General Electric Company
175 Curtner Avenue, San Jose, CA 95125

February 28, 1990
MFN No. 013-90
Docket No. STN 50-605
EEN-9011

Subject: **Submission of Responses to Additional Information as Requested
in NRC Letter from Dino C. Scaletti, Dated January 26, 1990**

Enclosed are thirty four (34) copies of the Chapter 10 responses to the subject Responses to Request for Additional Information (RAI) on the Standard Safety Analysis Report (SSAR) for the Advanced Boiling Water Reactor (ABWR).

Figure 10.2-2 TURBINE CONTROL VALVE FAST CLOSURE CHARACTERISTIC

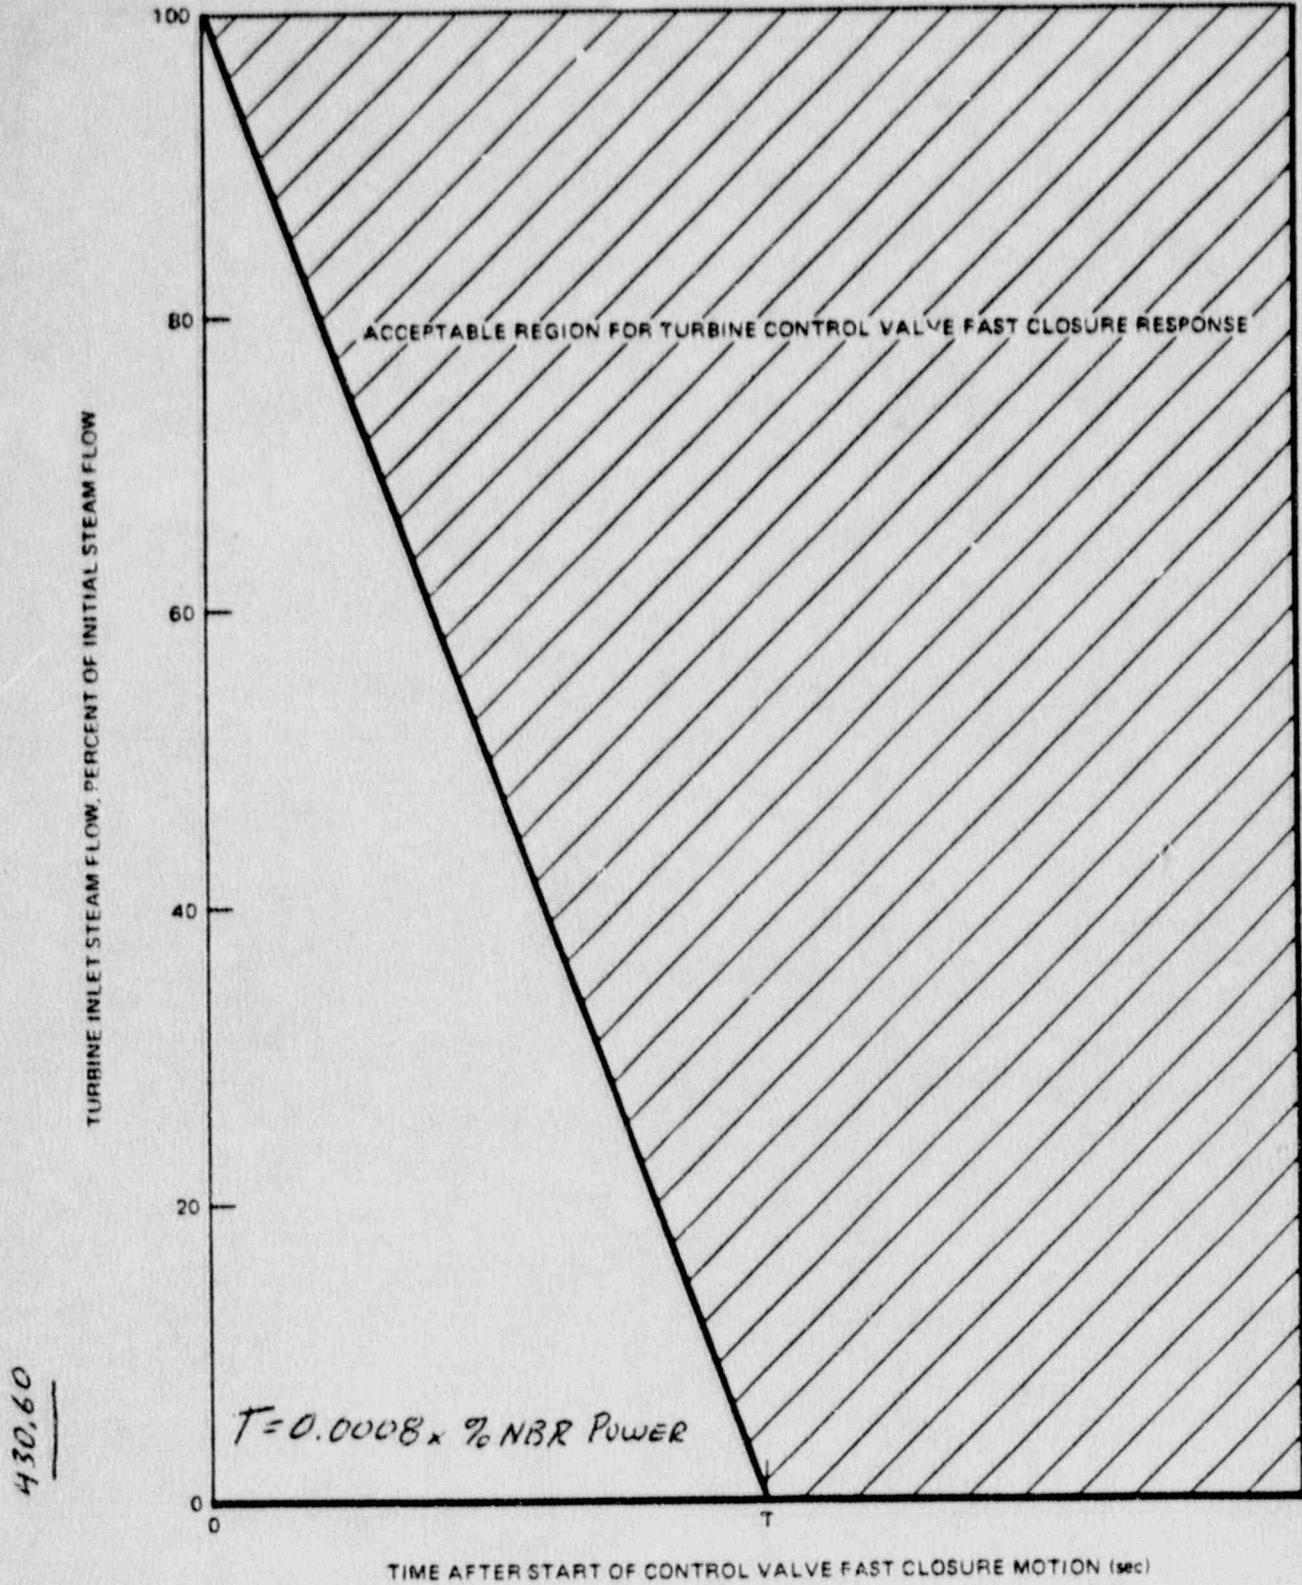
Specify the value for time "T" in Figure 10.2-2. (10.2)

Figure 10.2-2 has been revised to indicate $T(\text{sec}) = 0.0008 \times \% \text{ NBR Power}$.

Figure xyz. Simplified Functional Control Diagram of Turbine Digital Control and Monitoring System (Typical of One of Three Channels)

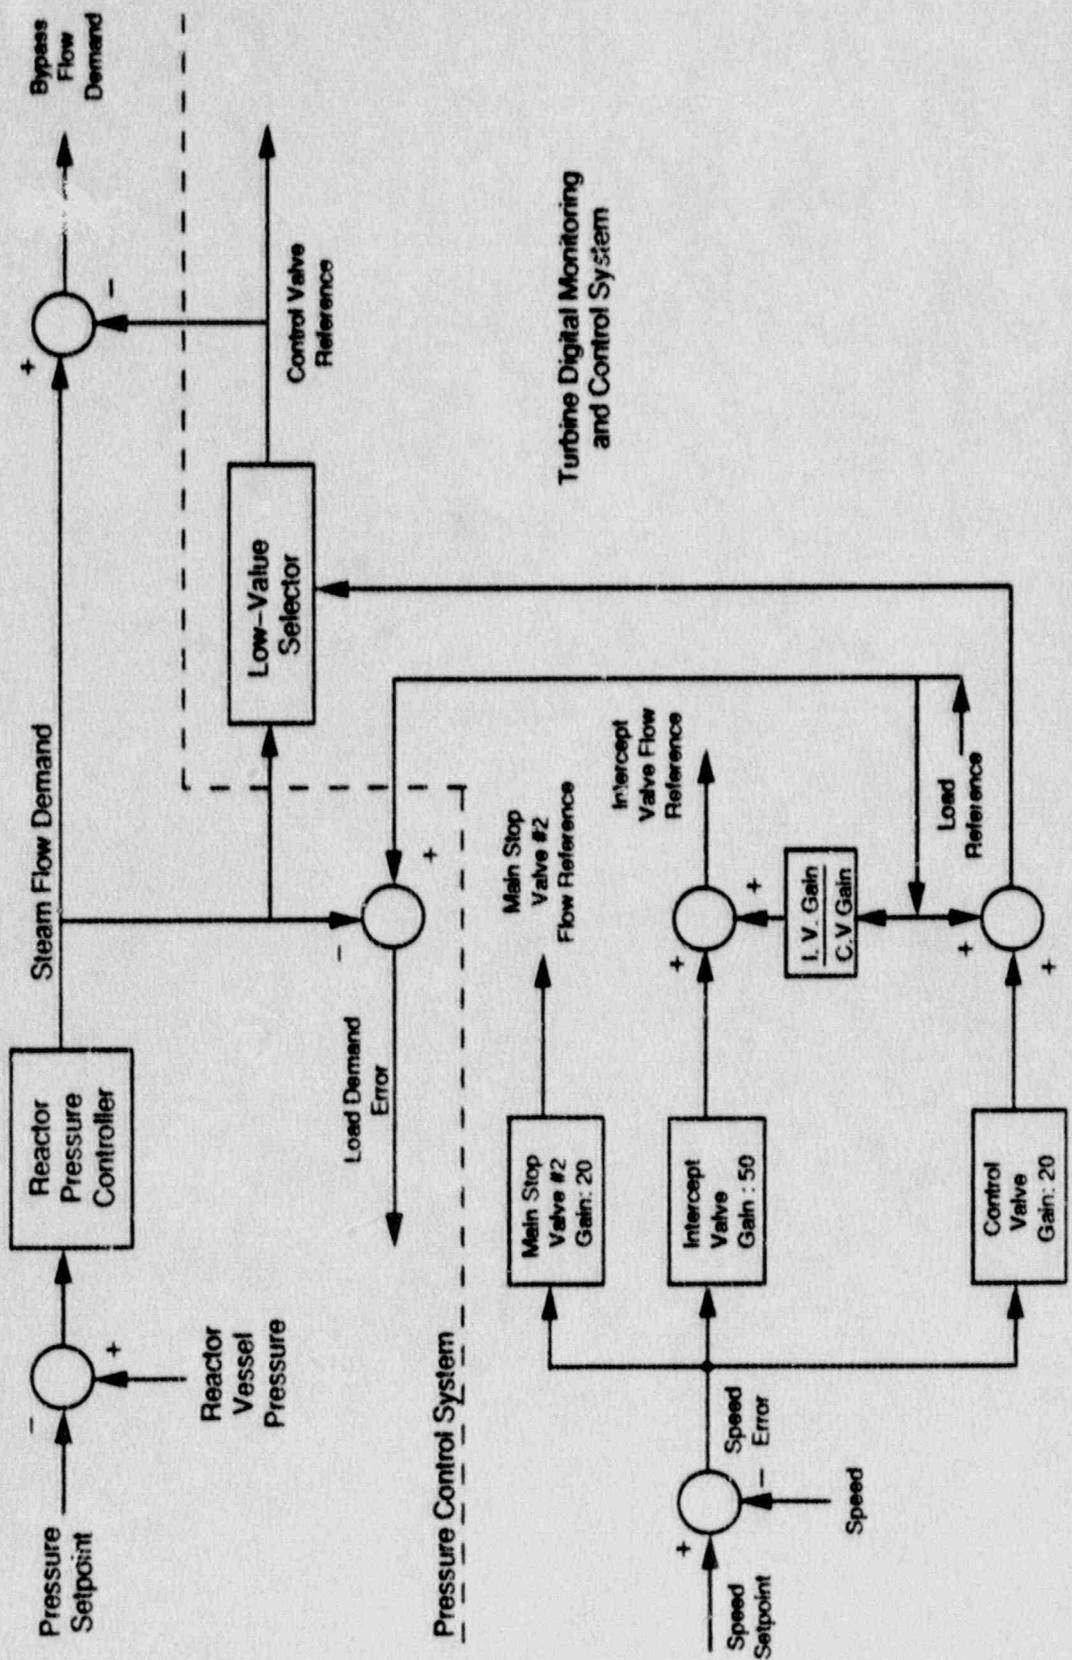
Provide a description of the speed control unit, the load control unit and the flow control unit of the electrohydraulic (EHC) system. Your description should include how they perform their intended functions. Clarify whether the EHC system will fully cut off steam at 103 percent of rated turbine speed. (10.2)

The main turbine EHC control system is now referred to as turbine digital control and monitoring (DCM) system. The DCM system, in conjunction with the reactor pressure control system, will provide manual and automatic control, protection and monitoring for the turbine-generator during normal operation of the unit. Specifically, the DCM will measure critical unit parameters, make and implement decisions, and regulate the position of the turbine main steam control valves to startup, load, unload and shutdown the unit. The system also includes built-in features to automatically protect the turbine-generator against abnormal operating conditions of overspeed, loss of oil, overheating, etc., which can be monitored and tested while the turbine-generator unit is in normal operation.

AIRBORNE TURBINE ISLAND DESIGN
 MAIN STEAM SUPPLY SYSTEM DIAGRAM
 Figure 10.3-1

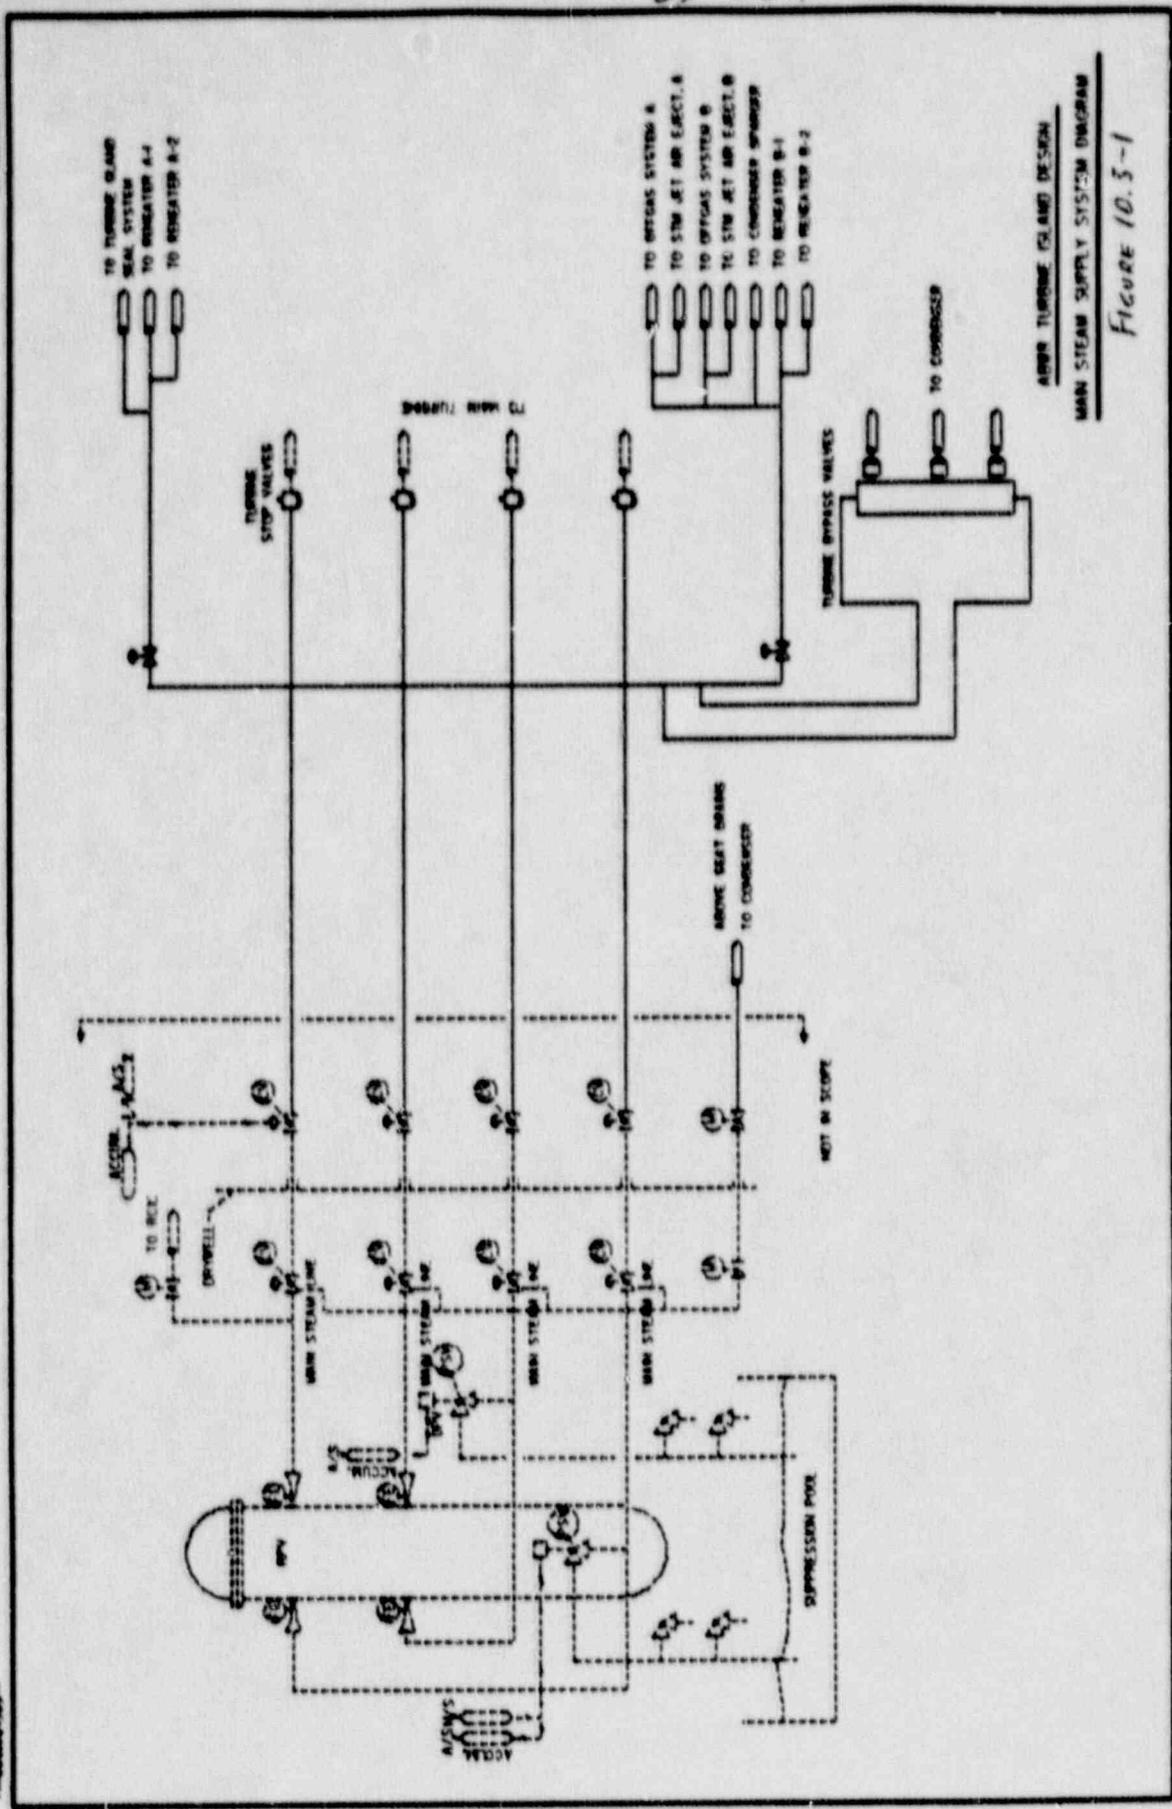
For the following items identified in SSAR Figure 10.3-1:

- a. Deaerating steam to condenser
- b. Offgas system
- c. Steam jet air ejectors
- d. Turbine gland sealing system
- e. Reheater
- f. Main steam bypass (turbine bypass)

- a. Maximum steam flow (lbs/hr)
- b. Type of shut-off valve(s)
- c. Size, quality, design code, closure time, actuation mechanism and associated motive power of the valve(s).

Figure 10.3-1 has been revised and shows the power cycle auxiliaries using main steam (all services other than the turbine bypass) divided into two groups such that the supply line to each group has one isolation valve.

The grouping of the steam supply services is made to facilitate the pipe routing. As an example the steam supply to the turbine gland seal system is grouped with the steam supply to reheaters A-1 and A-2. The turbine gland seal system and reheaters A-1 and A-2 are physically within close proximity of each other. Similarly, the steam supply to the condenser sparger, the steam jet air ejector, offgas system, and reheaters B-1 and B-2 are grouped together.

FIGURE 10.4-11
 SIGNAL FLOW CHART FOR TURBINE
 BYPASS CONTROL UNIT

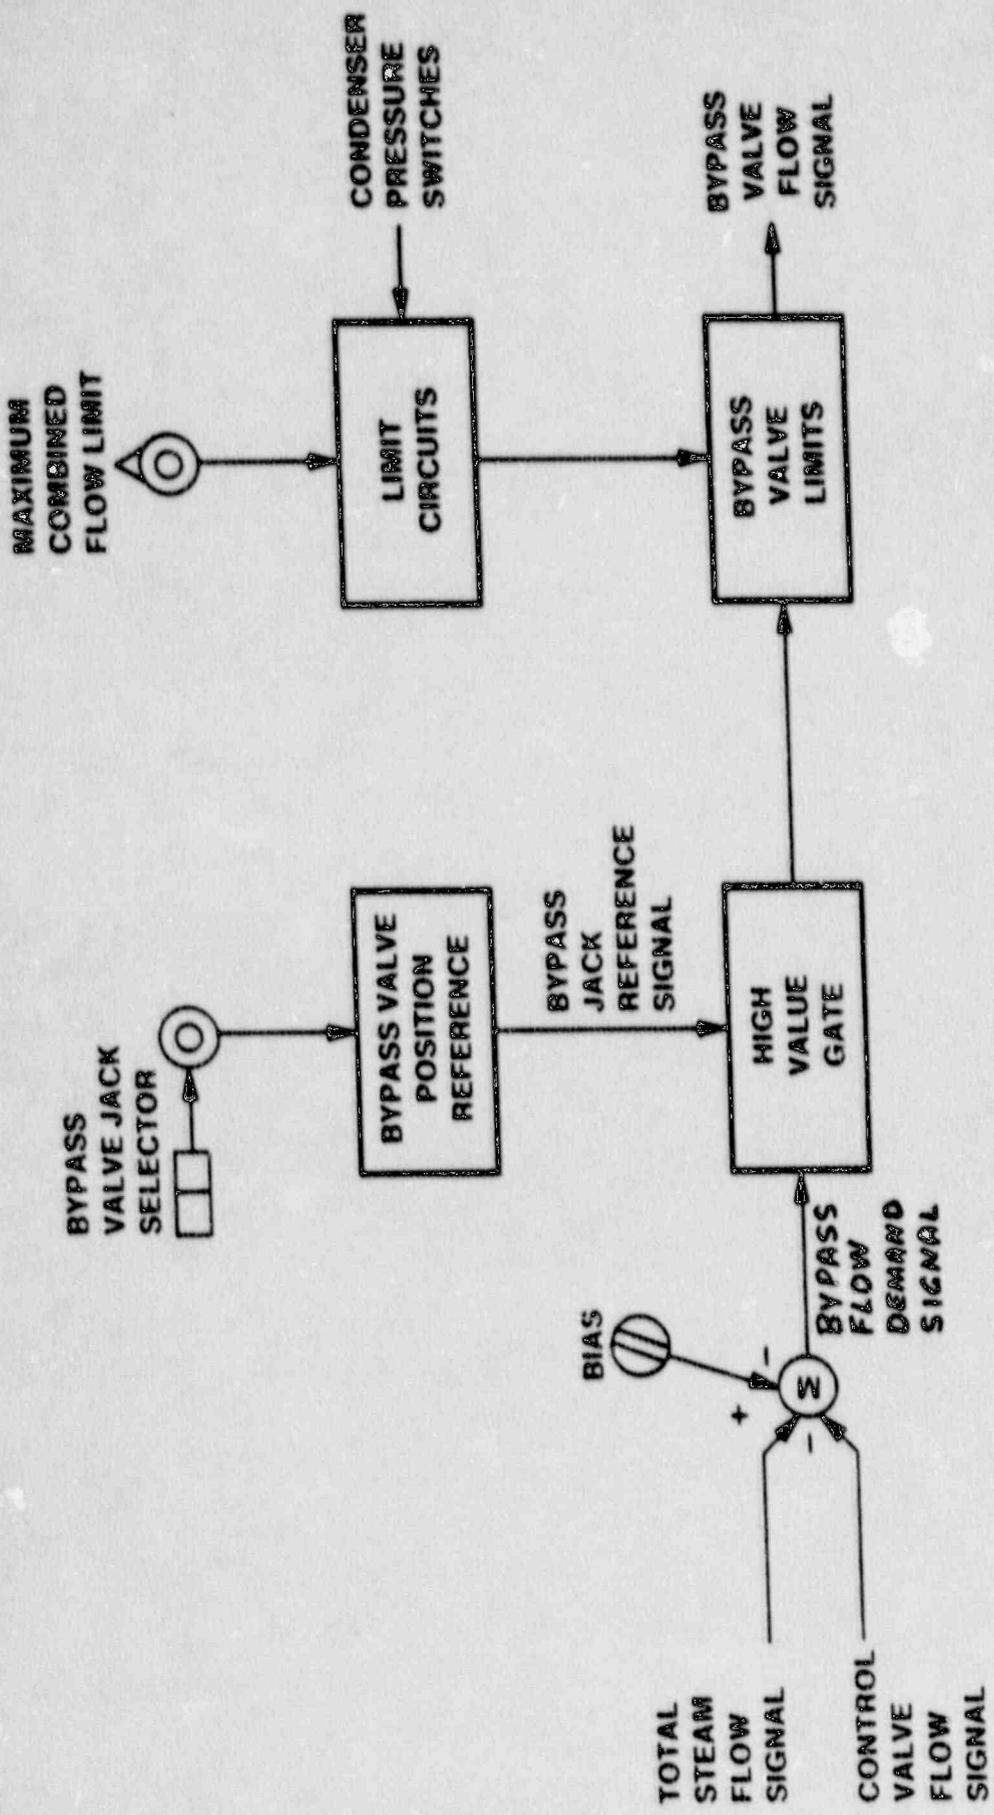
- (a) Provide figures which delineate the system and its components.
- (b) Clarify whether the system includes pressure-reducer assemblies for the bypass valves to reduce steam pressure prior to steam discharge into the condenser.

- (a) Figures 10.4-10 and 10.4-11 have been added to delineate the system and its components.
- (b) The detailed design will follow standard industry practice and reduce the pressure sequentially through orifices prior to entering the condenser. In addition, please note that the valves will be 9"
